SEWAGE DISPOSAL SYSTEM

HOWARD COUNTY HEALTH DEPARTMENT
BUREAU OF ENVIRONMENTAL HEALTH
410-313-2640

SUBDIVISION Brantwood LOT NUMBER 4 ADDRESS 11417 Butterfruit Way

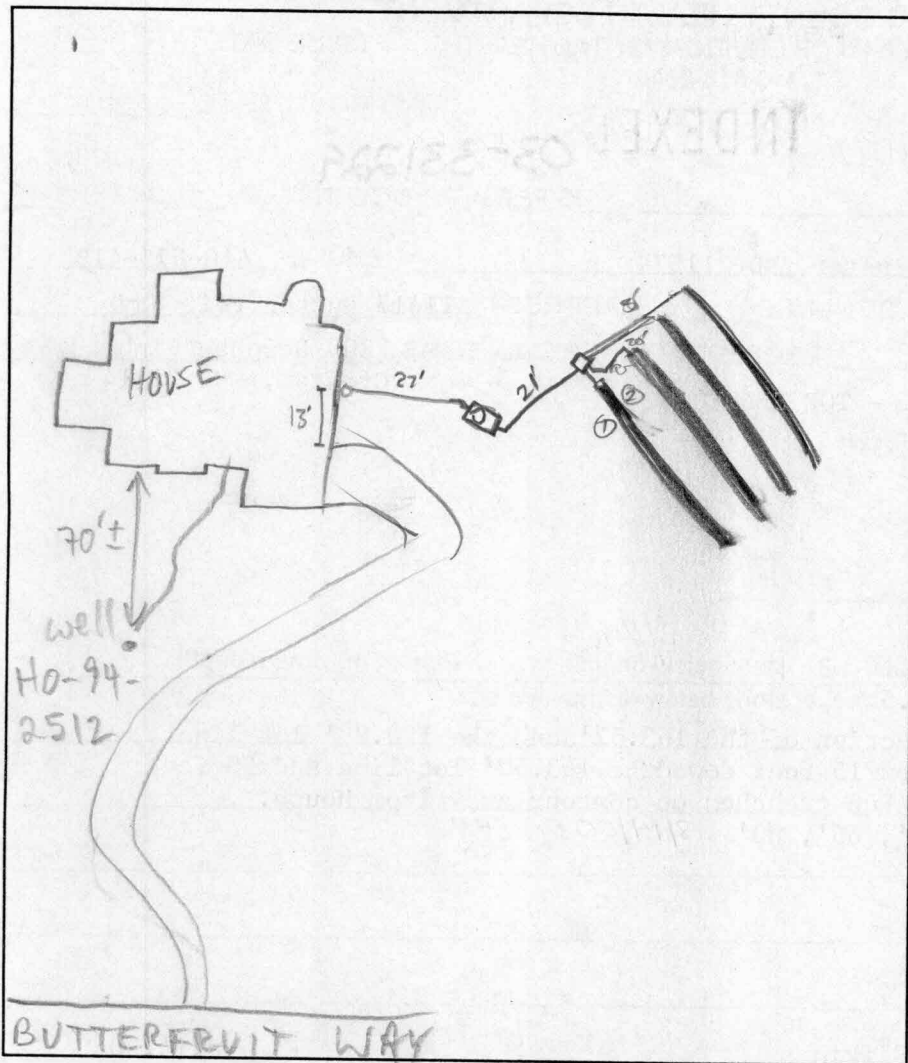
PRE-CONSTRUCTION INSPECTION: 4/26/01 SDA staked - layout confirmed - OK to begin system installation. (DK)

INSPECTION COMMENTS: 4/30/01 - INLET MAY NEED TO BE DROPPED TO 4' BUT SAME BOTTOM DEPTH SHOULD BE KEPT & SAME AMOUNT OF STONE (MORE STONE ABOVE PIPE OK) - (RW)

connecting pipe to dist box, first 25' of Tr #1 (40') and first 15' of Tr #2 (55') opened and Tr #1 gravelled, OK to continue (Red HL-CL in top 4', then bedded Tan Mica Lenses below). APP 5/2/01

5/7/01 House connection not made. OK to cover septic work. NO FINAL APPROVAL. DYC 6/18/01 HOUSE CONN OK (MR)
